**Subject:** NYM/2023/0876 - Superseded Documents

# Raithwaite - Hotel Remodelling

Design and Access Statement

Revision P2

# Bar rooflight

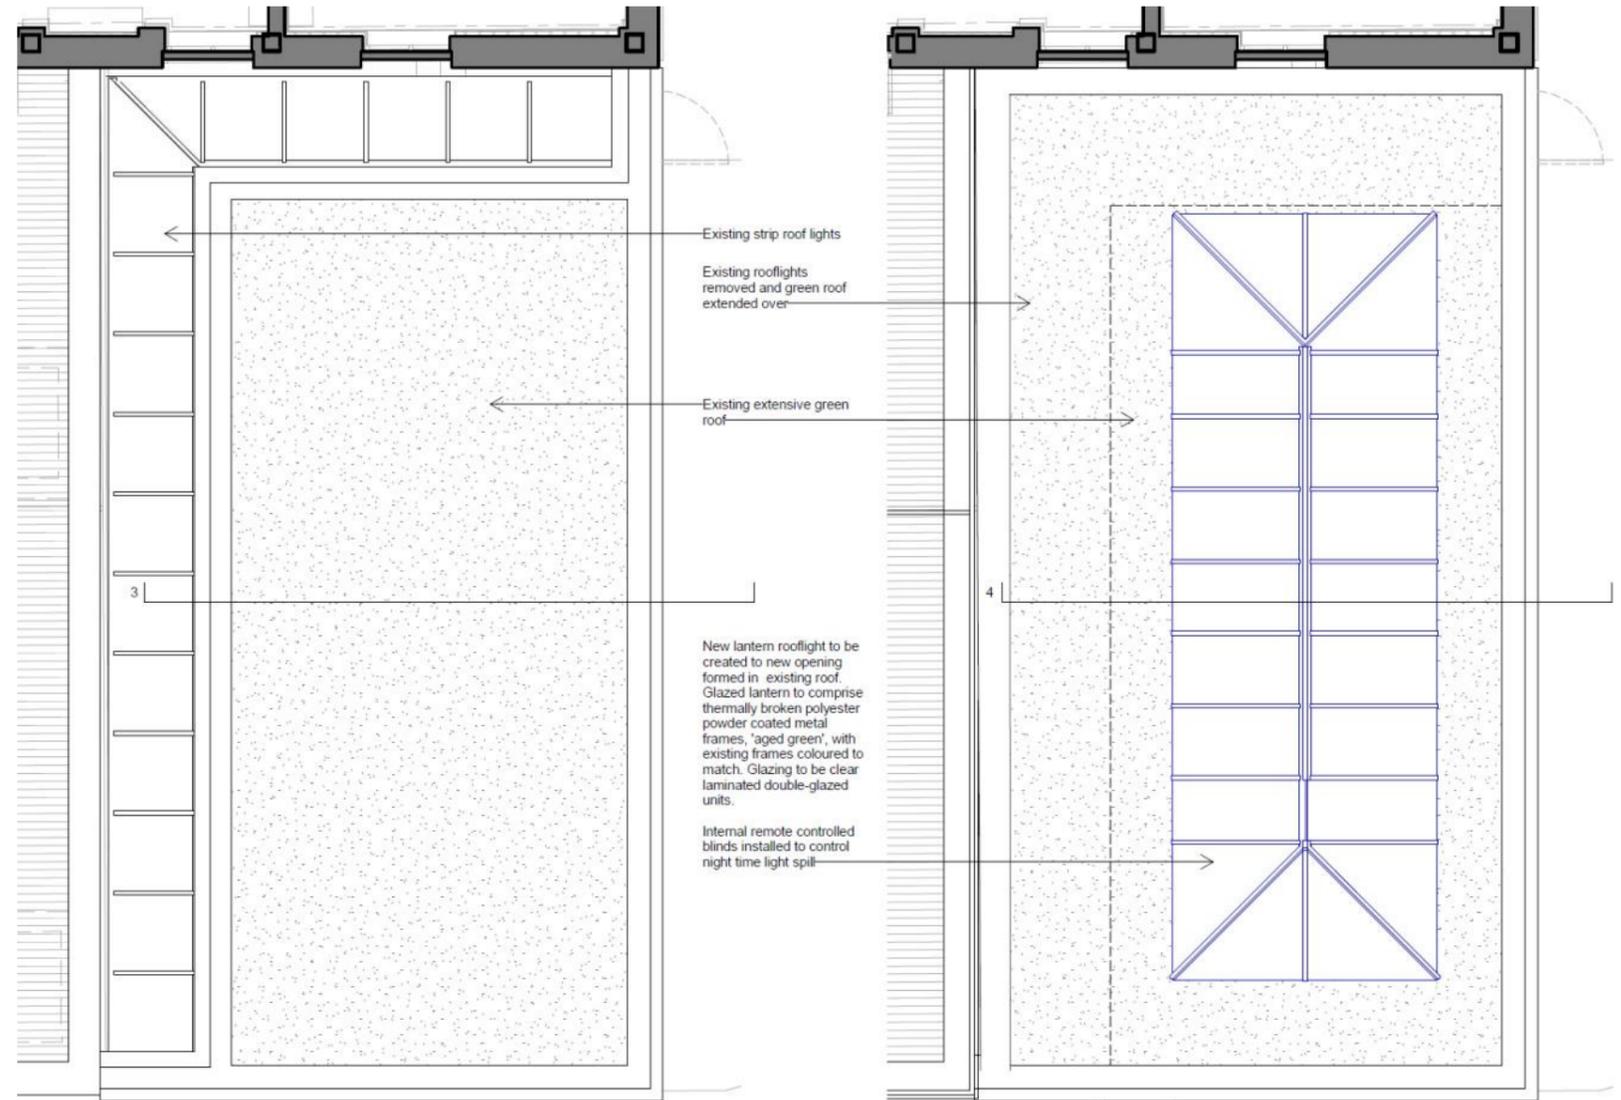
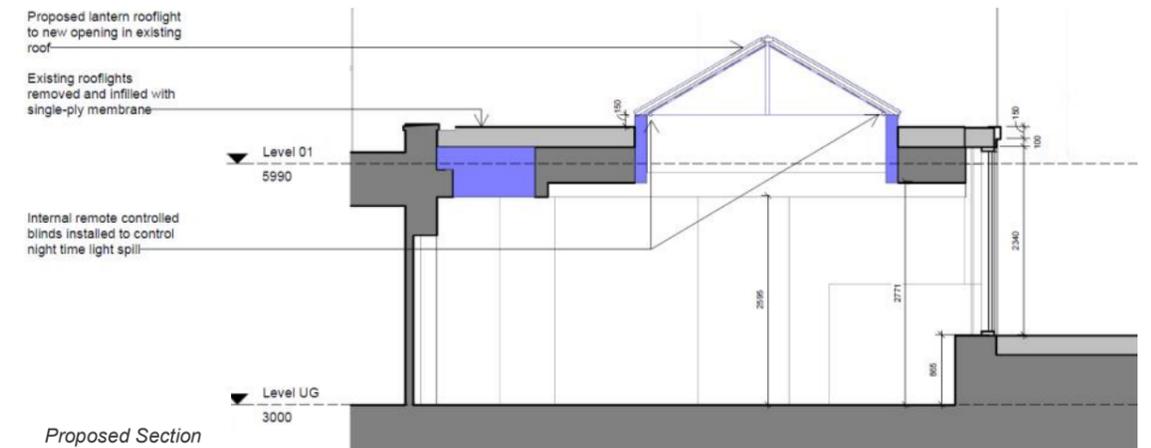
##### **P18 Bar Rooflight**

- Addition of paragraph describing installation of blinds to mitigate potential impact on Dark Night Skies / Drawings updated to reference installation of blinds.

The proposed roof lantern will replace the existing strips of horizontal roof lights which run along the edge of the existing bar edge which are proposed to be filled in as part of proposals to mitigate the impact of the roof lantern on Dark Night Skies in policy ENV 4.

In addition, the installation of remote controlled blinds to the inside of the new lantern, which will close at dusk, will ensure that there will be a net reduced impact on Dark Night Skies.

# Spa Façade Alterations

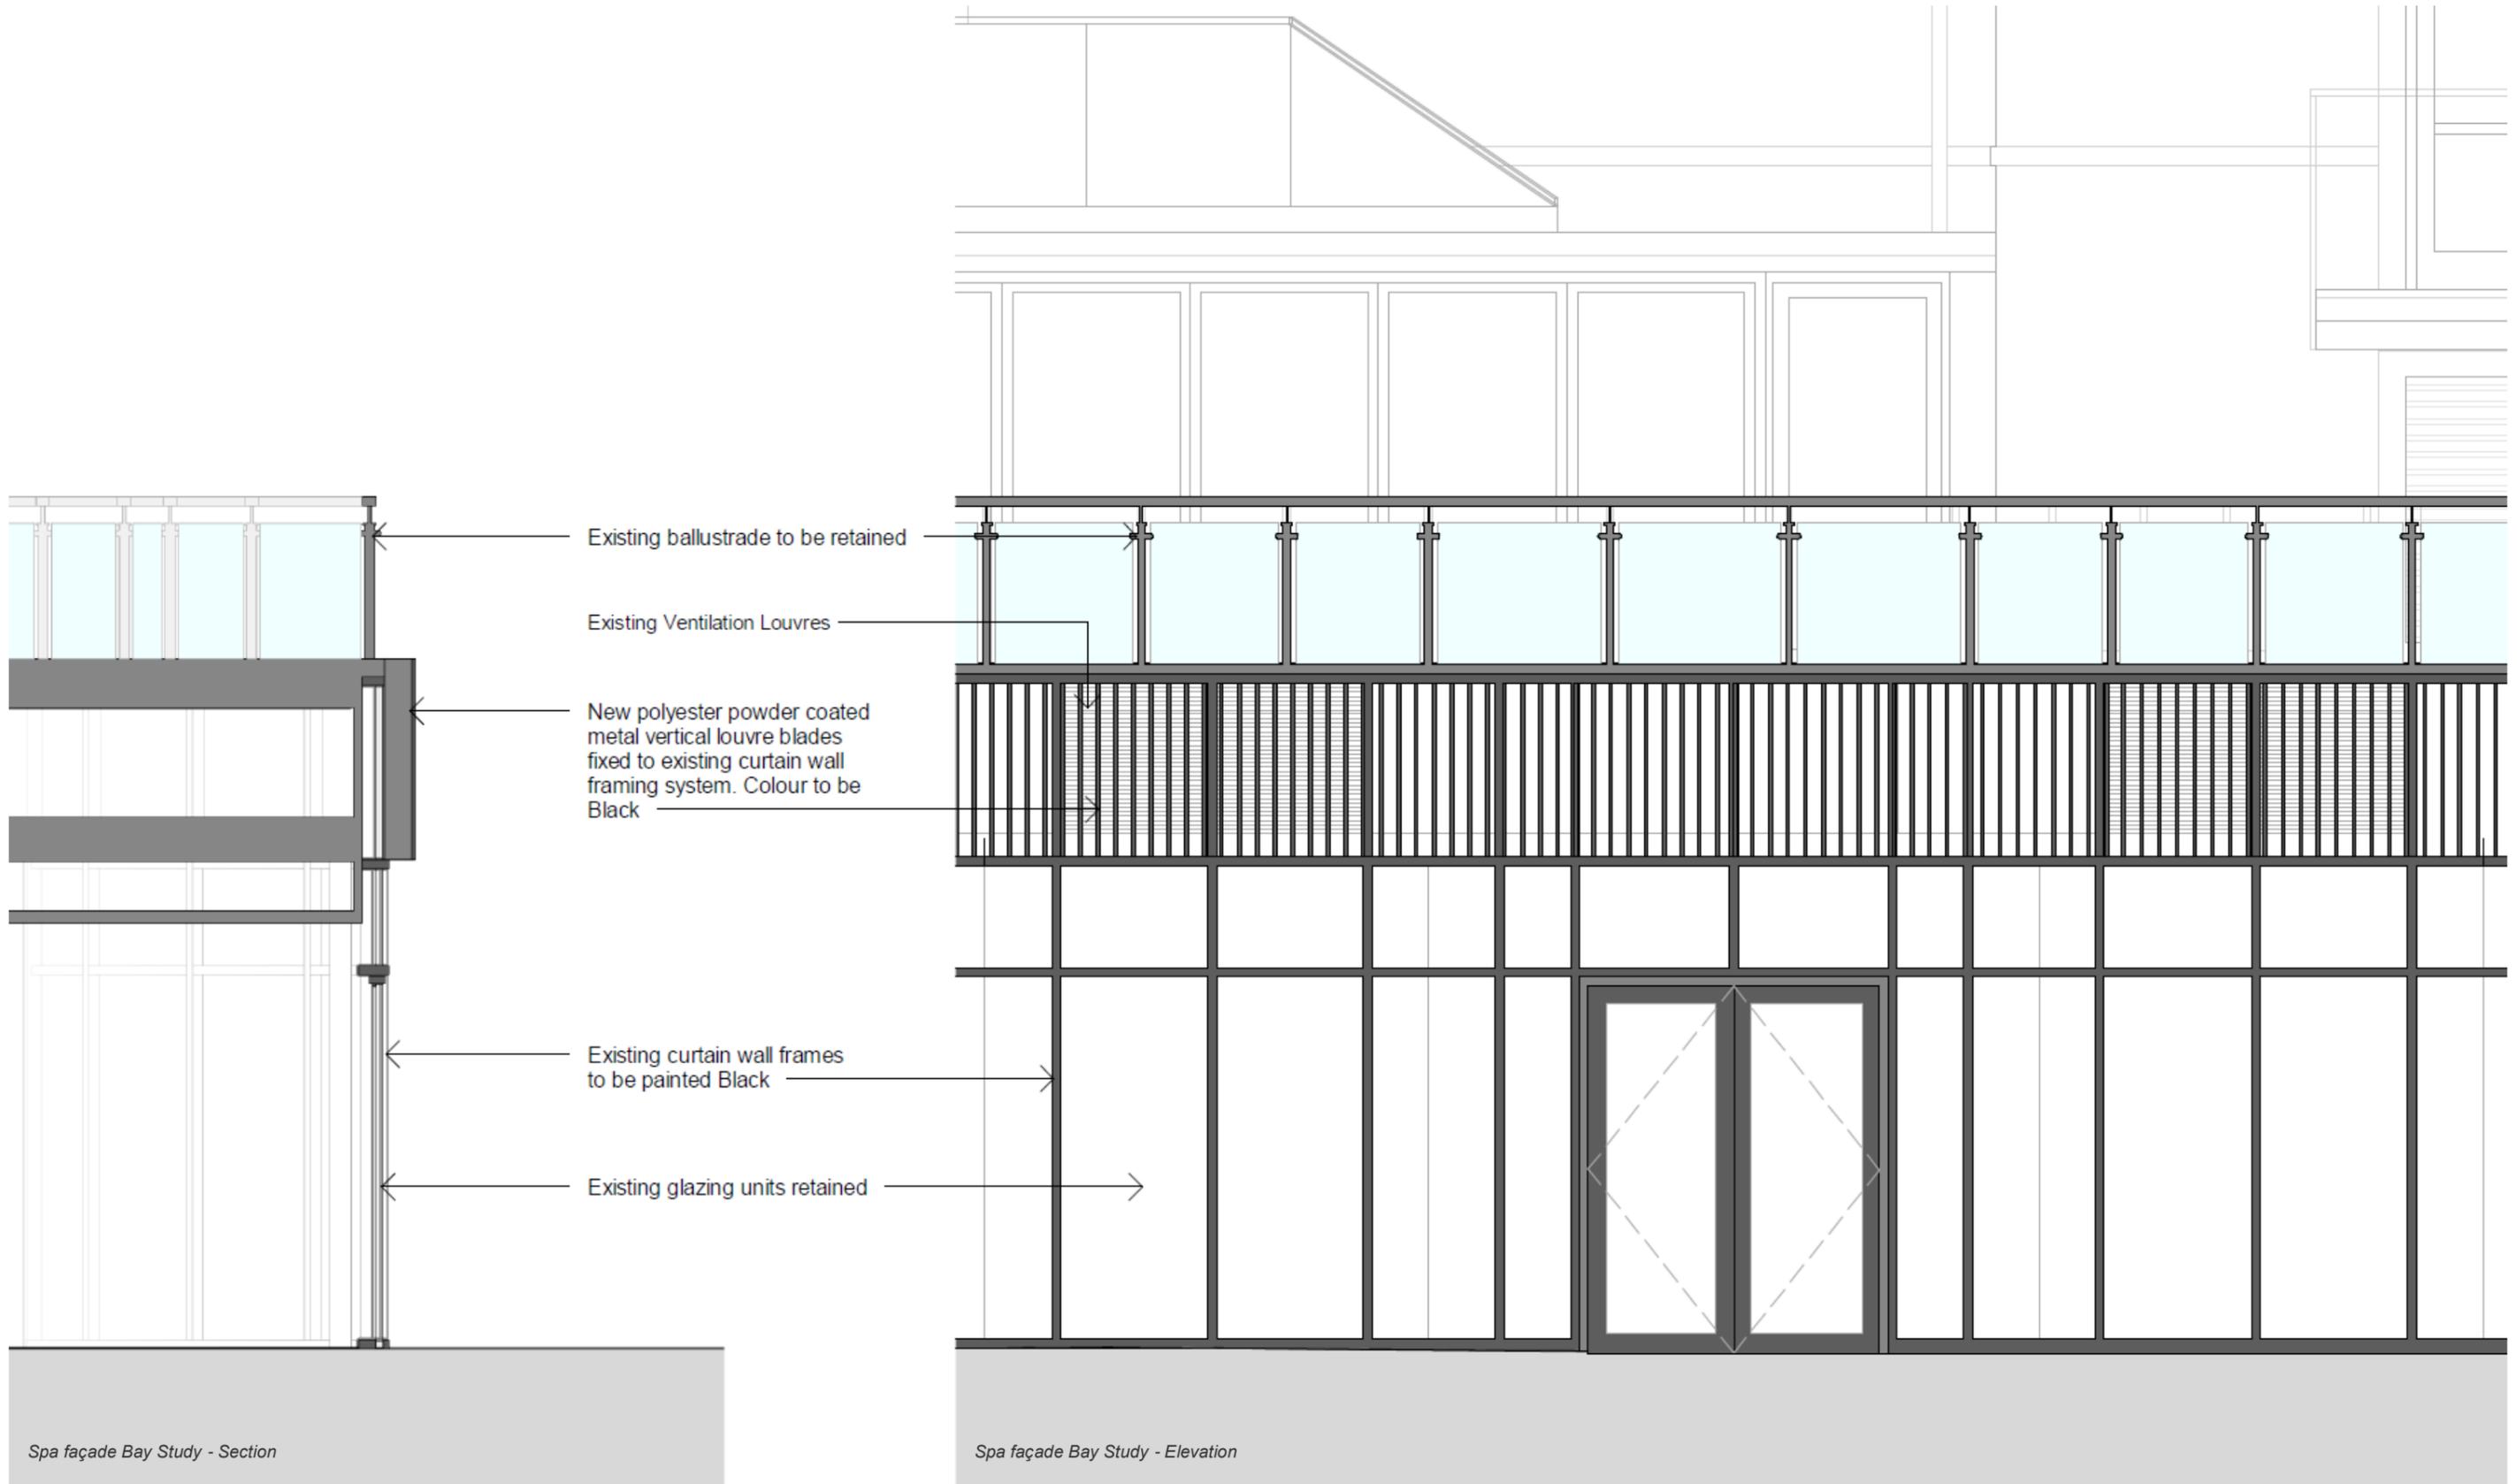
##### **P19 Spa Façade Alterations**

- Reference to change of glazing and addition of brise soleil removed / Reference to controlled illumination levels added.

##### **P20 Spa Façade Alterations**

- Proposed façade treatment view updated.

Reference to change of glazing and addition of brise soleil removed / Reference to controlled illumination levels added

Proposed façade treatment view updated

The internal alterations also provide an opportunity to reduce the impact of night time use on the Dark Night Sky (Policy ENV4) by ensuring that interior lighting in general use be provided only to provide ambient light levels (50 lux).

Project				
Raithwaite Sandsend, Whitby O'Shea				
Title				
Proposed Bar Glazed Roof				
Job No	Scale at	Status	Rev.	Ext.
4199	1 : 50	S1	P02	
Project Originator Zone Level Type Role Sheet				
RTWT -HMA - 07 - UG -DR - A - 00303

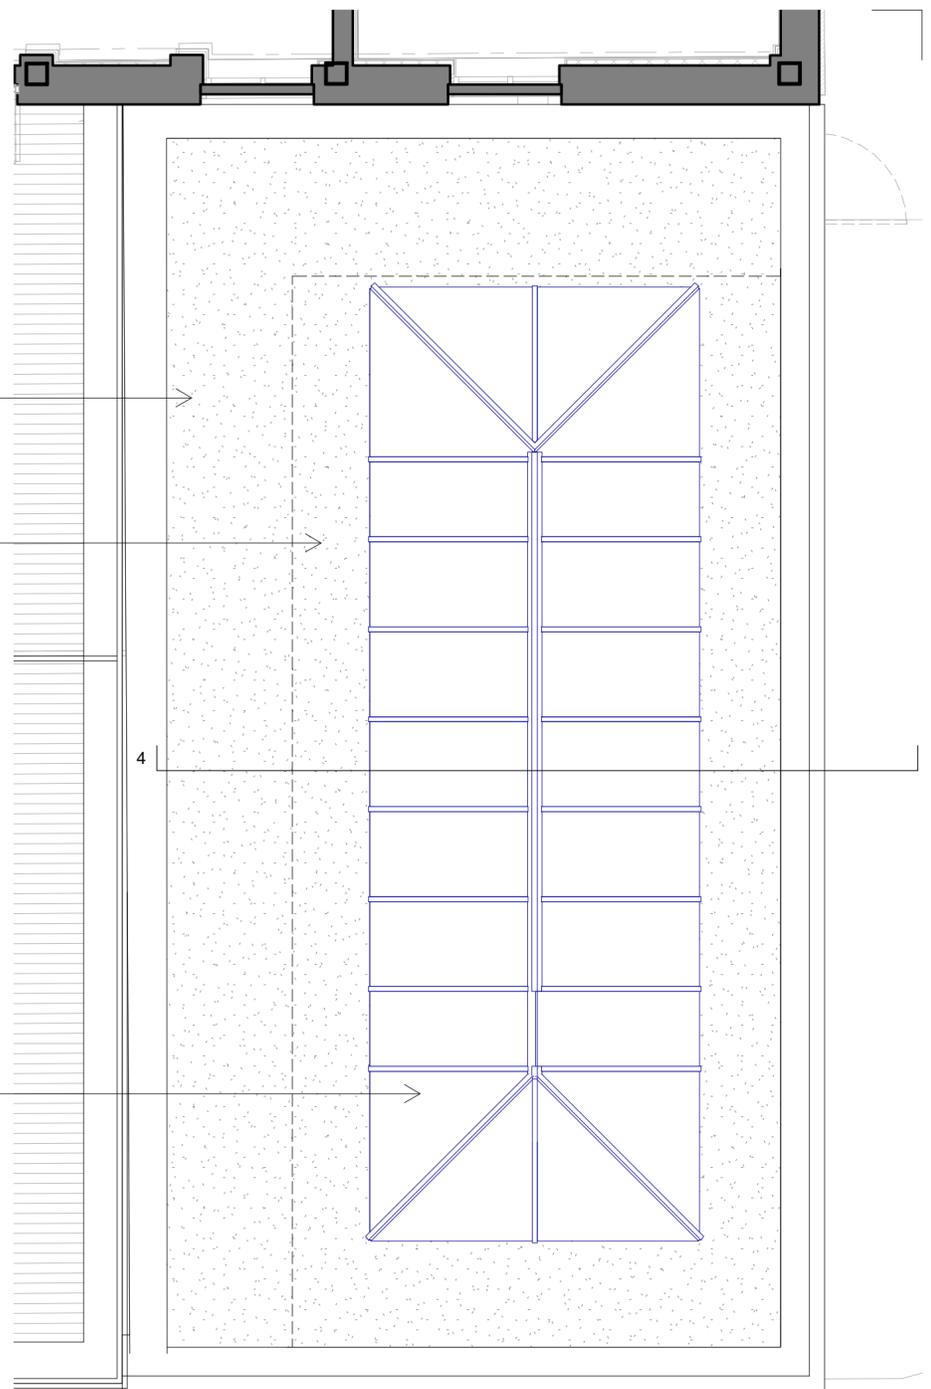
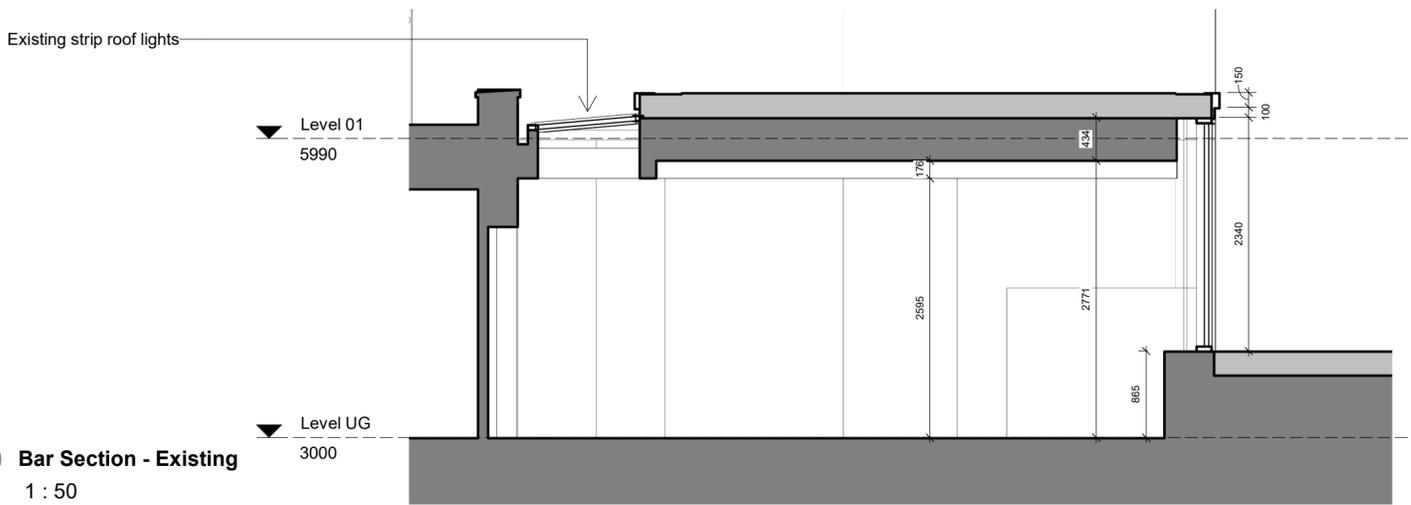
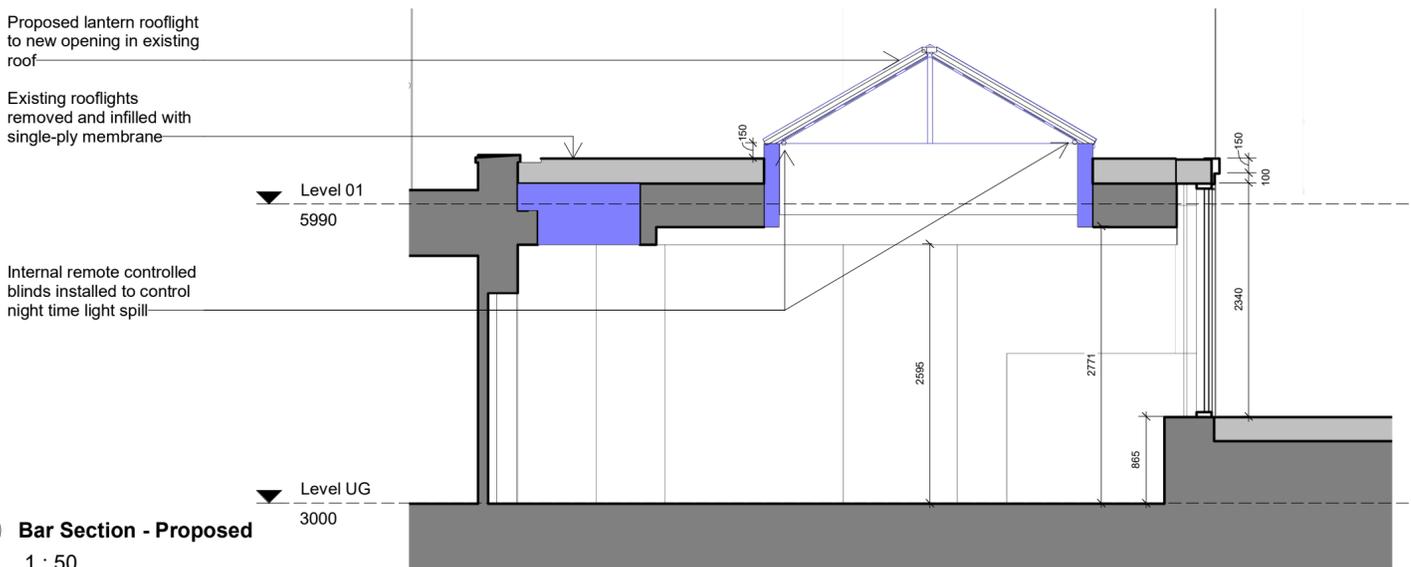
Addition of paragraph describing installation of blinds to mitigate potential impact on Dark Night Skies / Drawings updated to reference installation of blinds

Internal remote controlled blinds installed to control night time light spill

Existing rooflights removed and infilled with single-ply membrane

Internal remote controlled blinds installed to control night time light spill

Title  
Proposed Spa Cafe Bay Study

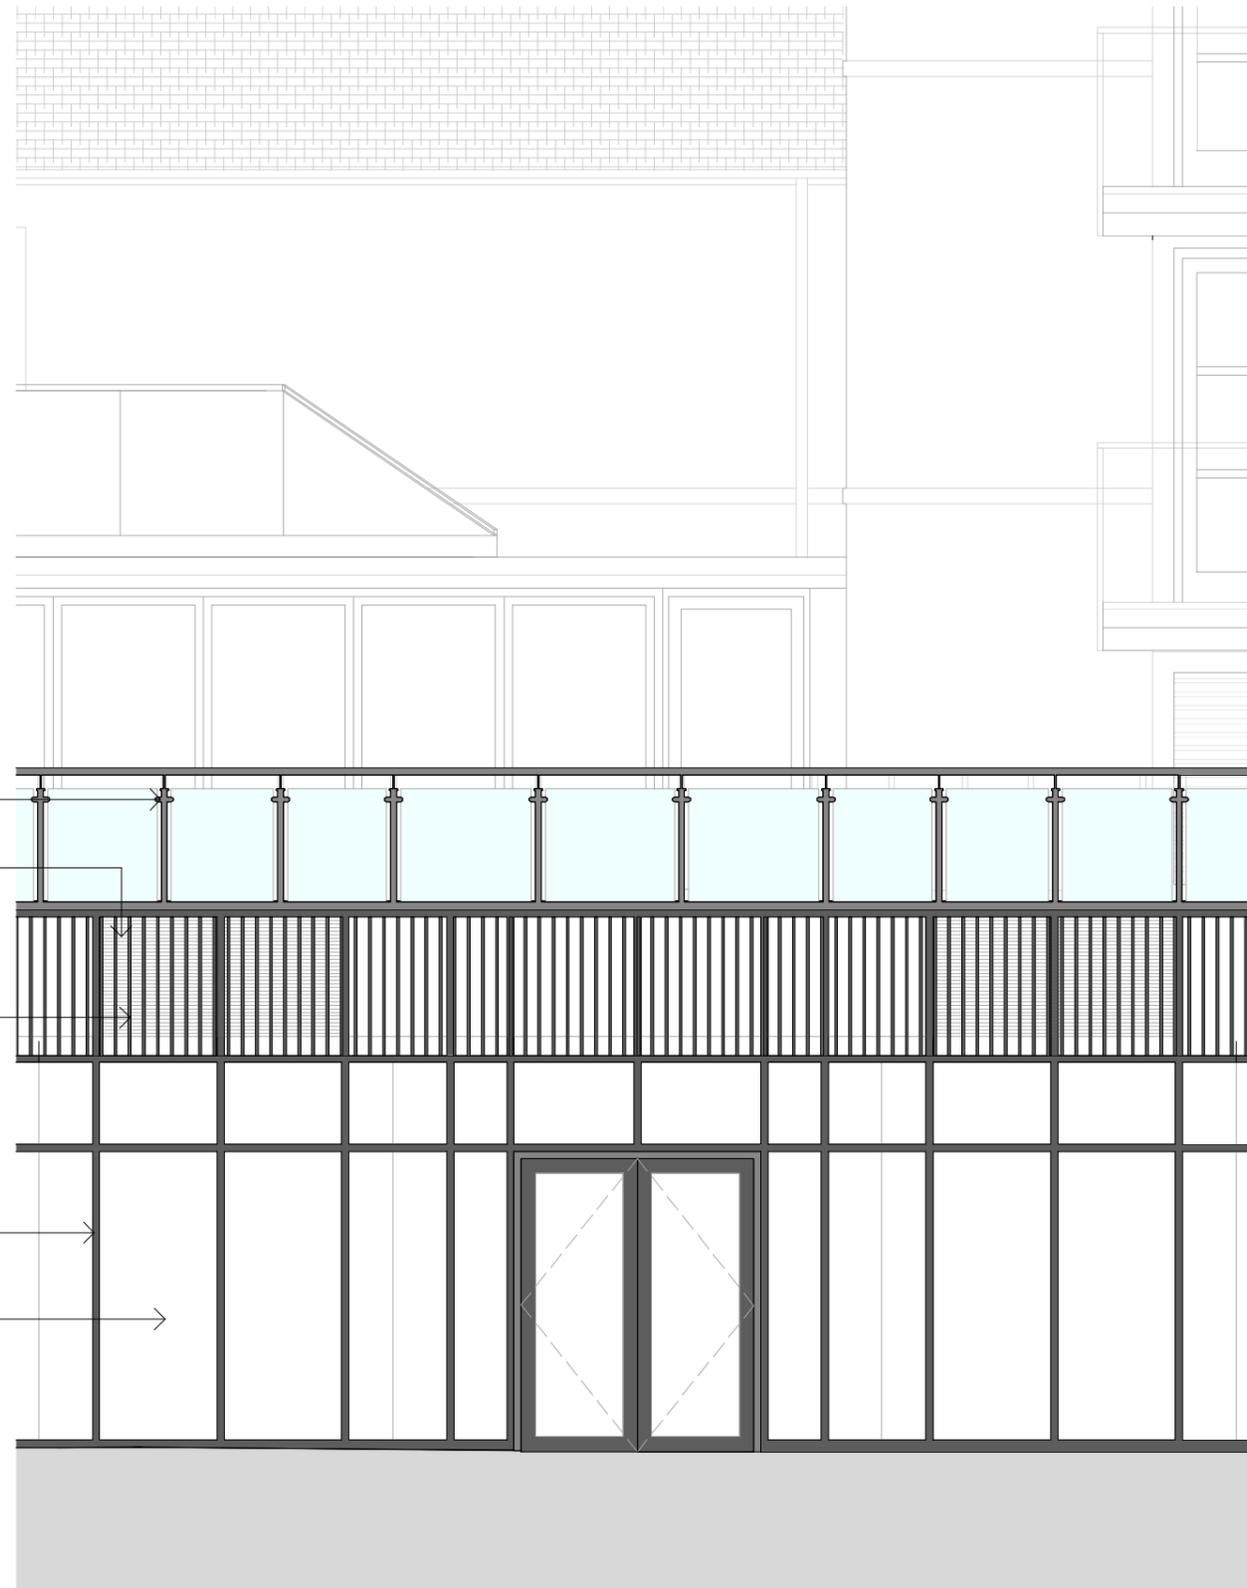
##### **P21 Spa Façade Alterations**

- Proposed bay study updated.

Proposed bay study updated

New polyester powder coated metal vertical louvre blades fixed to existing curtain wall framing system. Colour to be Black

Existing curtain wall frames to be painted Black

Existing glazing units retained
